STM32L15xxC and STM32L162xC device errata

This document applies to the part numbers of STM32L15xxC and STM32L162xC devices and the device variants as stated in this page.

It gives a summary and a description of the device errata, with respect to the device datasheet and reference manual RM0038.

Figure 1. Masked RTC interrupt

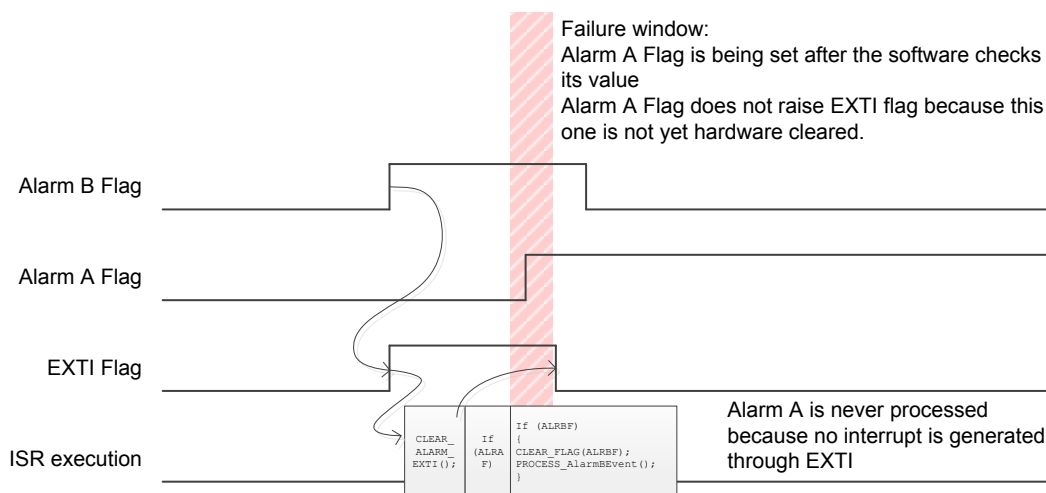
The following code example and figure illustrate the failure mechanism: The Alarm A event is lost (fails to generate interrupt) as it occurs in the failure window, that is, after checking the Alarm A event flag but before the effective clear of the EXTI interrupt flag by hardware. The effective clear of the EXTI interrupt flag is delayed with respect to the software instruction to clear it.
